ENGINEERING AMENDMENT:

TO AN APPLICATION FOR
A NEW NON-COMMERCIAL
EDUCATIONAL FM STATION
CHANNEL 215 B, 90.9 MHZ

SHAFTER, CALIFORNIA

SKYRIDE UNLIMITED, INC.

EXHIBIT VB-8
VERTICAL PLAN SKETCH

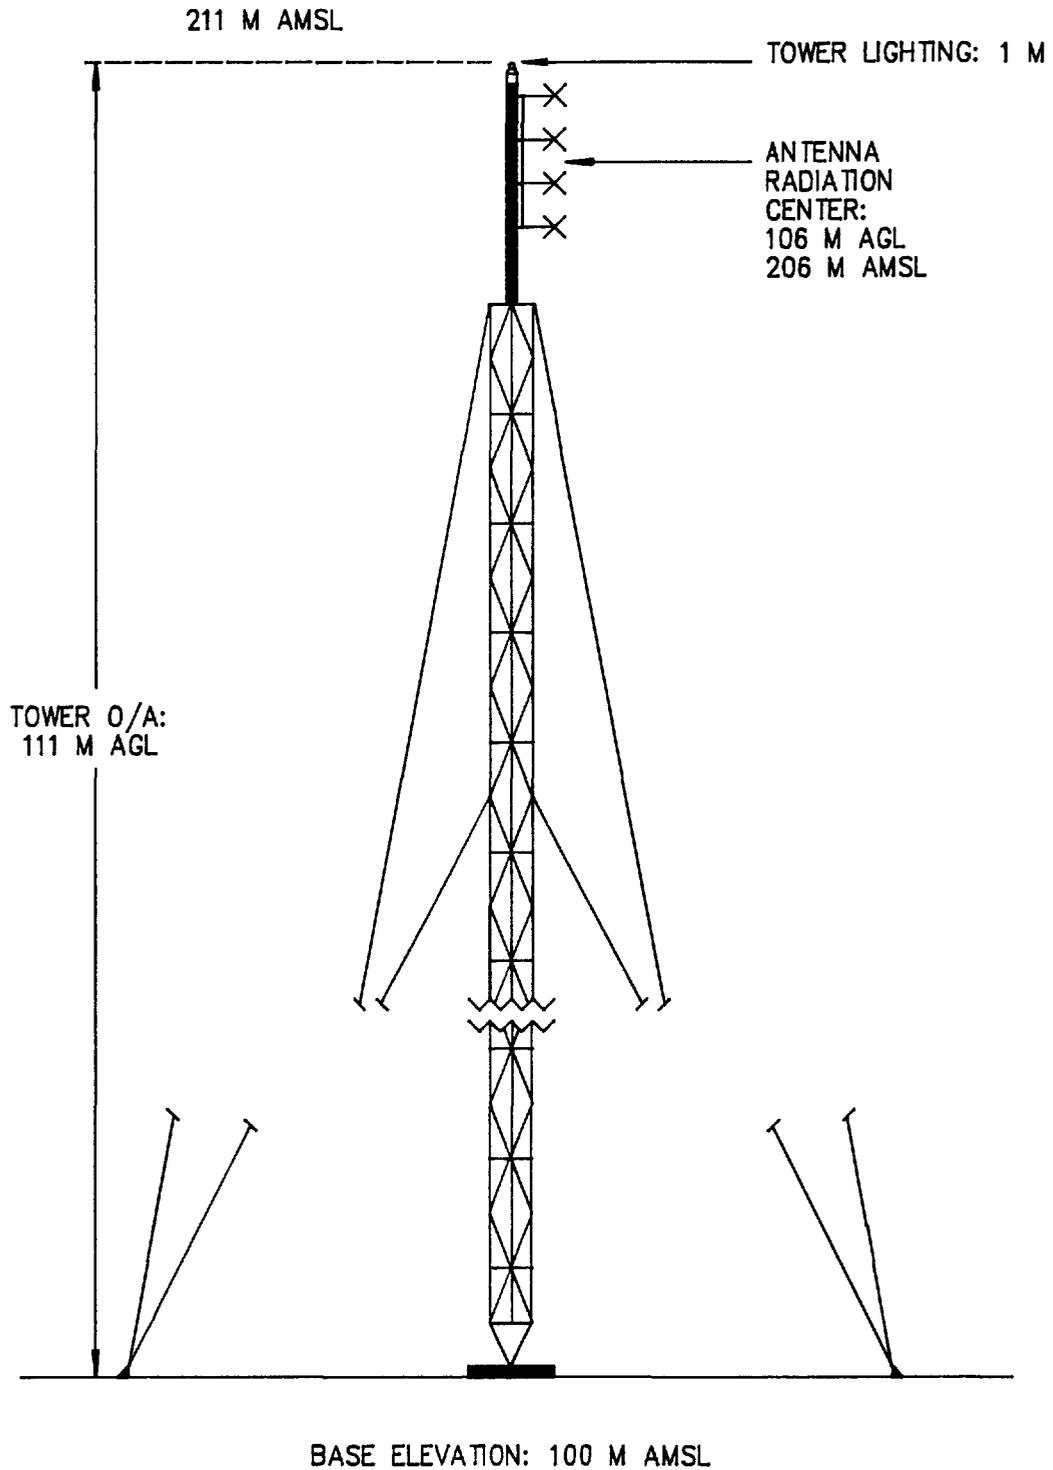
This Engineering Amendment supplies additional and corrected data to an application, BPED-901004MM, for a new non-commercial educational FM station at Shafter, California, previously submitted by Skyride Unlimited, Inc. In response to letter #8920-AJA from the F.C.C. dated October 22, 1991, the vertical plan sketch and form 340 V-B have been revised to correct metric conversion round-off error. The amended pages specify an overall tower height that is in agreement with the tower file database. This error results from the fact that the Commission requires data to be submitted in whole meters while the F.A.A. requires that data be submitted in feet.

EXHIBIT VB-8
 VERTICAL PLAN SKETCH

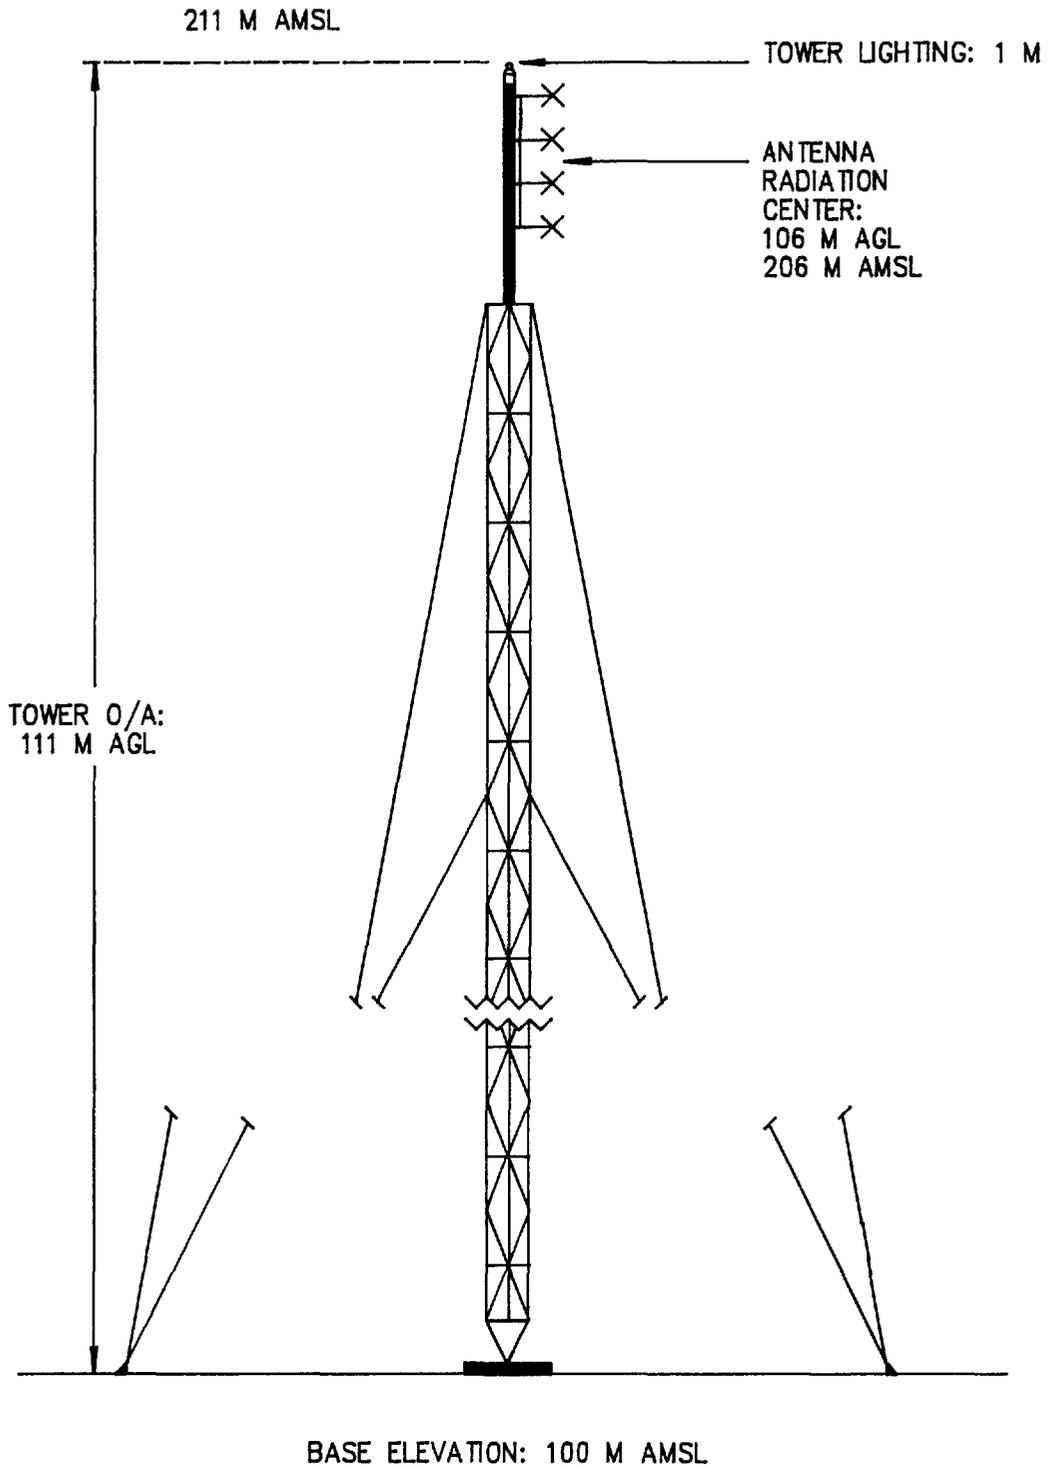
This Engineering Amendment supplies additional and corrected data to an application, BPED-901004MM, for a new non-commercial educational FM station at Shafter, California, previously submitted by Skyride Unlimited, Inc. In response to letter #8920-AJA from the F.C.C. dated October 22, 1991, the vertical plan sketch and form 340 V-B have been revised to correct metric conversion round-off error. The amended pages specify an overall tower height that is in agreement with the tower file database. This error results from the fact that the Commission requires data to be submitted in whole meters while the F.A.A. requires that data be submitted in feet.

EXHIBIT VB-8
VERTICAL PLAN SKETCH
NEW NCE FM SHAFTER, CA 10/91

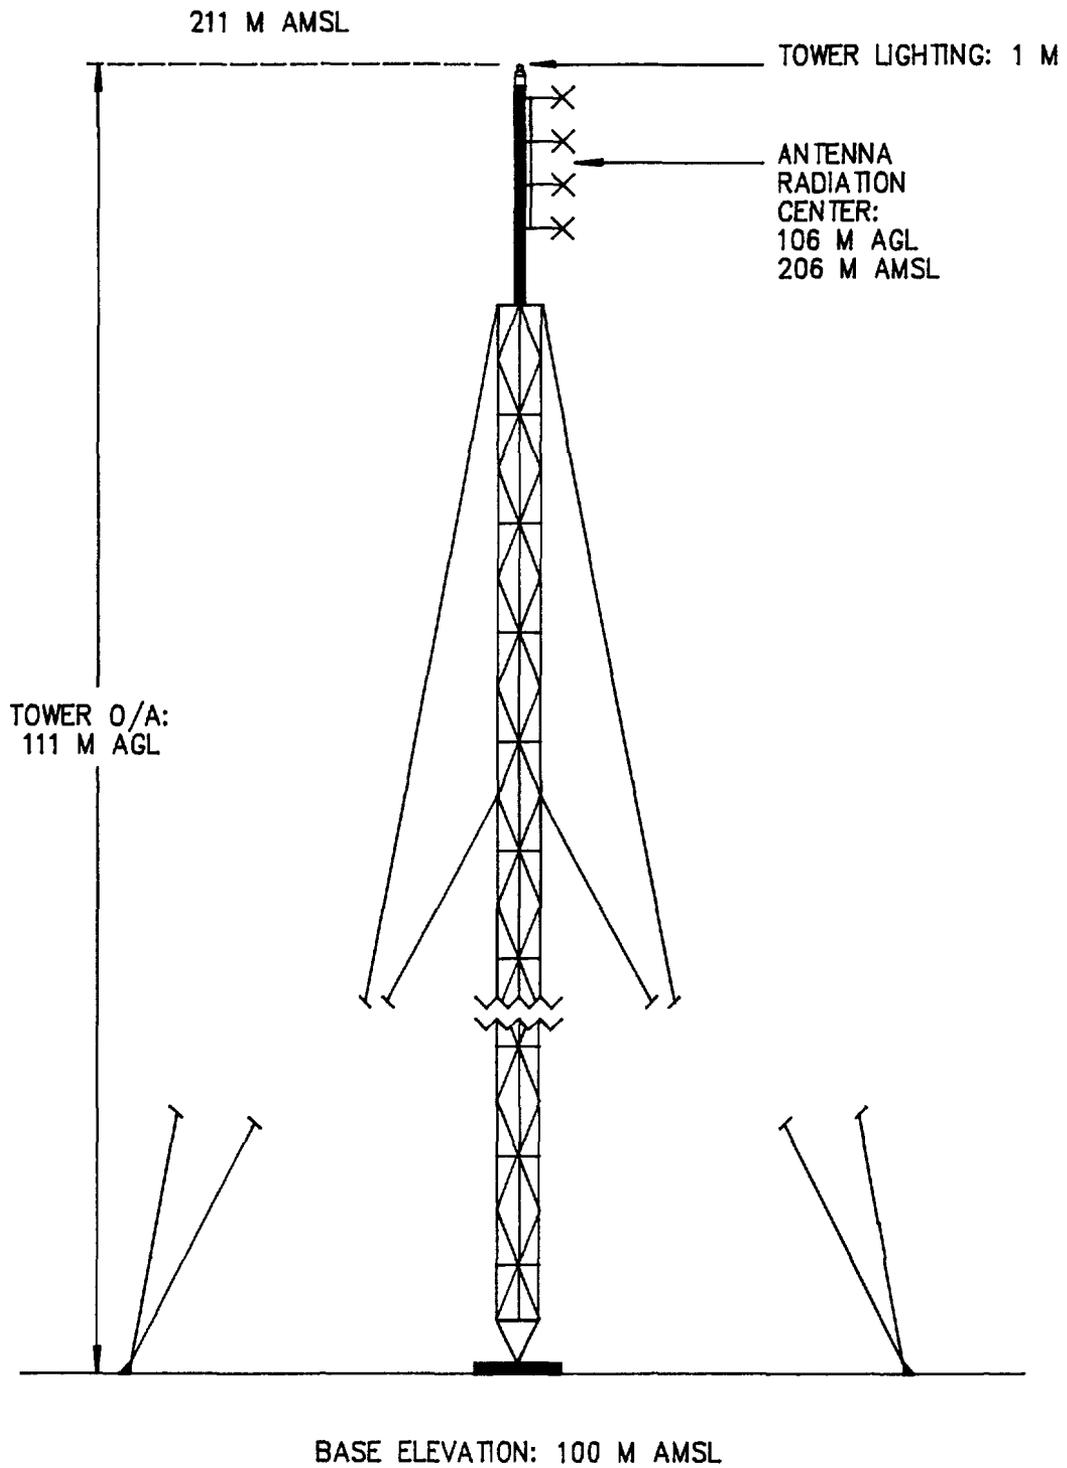
This Engineering Amendment supplies additional and corrected data to an application, BPED-901004MM, for a new non-commercial educational FM station at Shafter, California, previously submitted by Skyride Unlimited, Inc. In response to letter #8920-AJA from the F.C.C. dated October 22, 1991, the vertical plan sketch and form 340 V-B have been revised to correct metric conversion round-off error. The amended pages specify an overall tower height that is in agreement with the tower file database. This error results from the fact that the Commission requires data to be submitted in whole meters while the F.A.A. requires that data be submitted in feet.

EXHIBIT VB-8
VERTICAL PLAN SKETCH

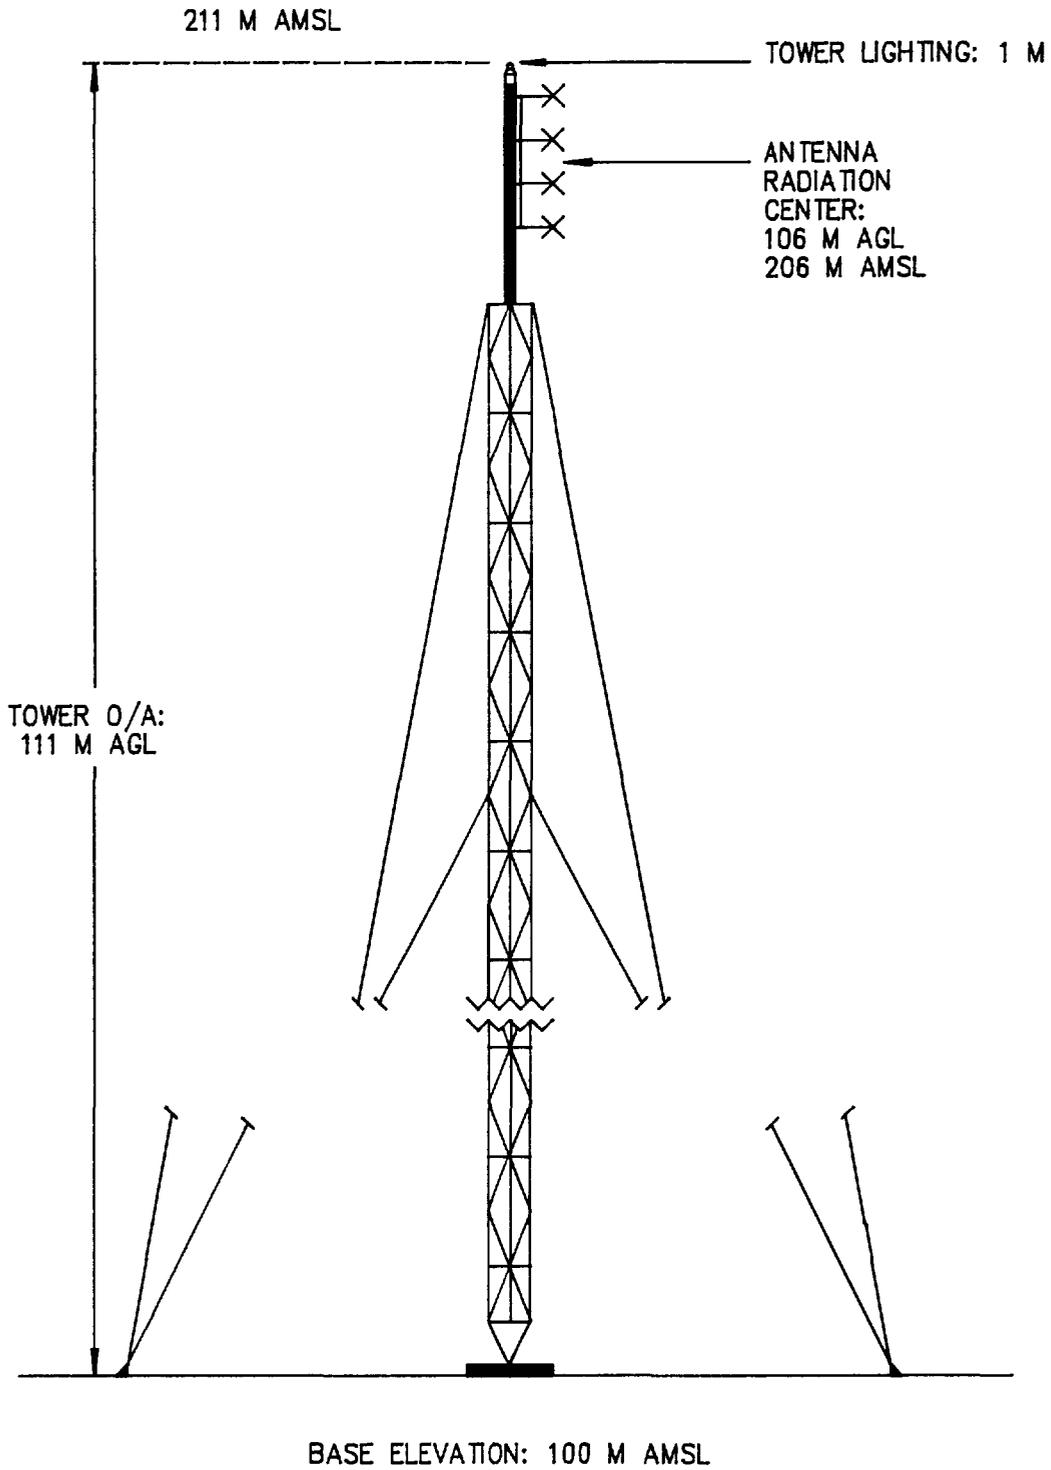
This Engineering Amendment supplies additional and corrected data to an application, BPED-901004MM, for a new non-commercial educational FM station at Shafter, California, previously submitted by Skyride Unlimited, Inc. In response to letter #8920-AJA from the F.C.C. dated October 22, 1991, the vertical plan sketch and form 340 V-B have been revised to correct metric conversion round-off error. The amended pages specify an overall tower height that is in agreement with the tower file database. This error results from the fact that the Commission requires data to be submitted in whole meters while the F.A.A. requires that data be submitted in feet.
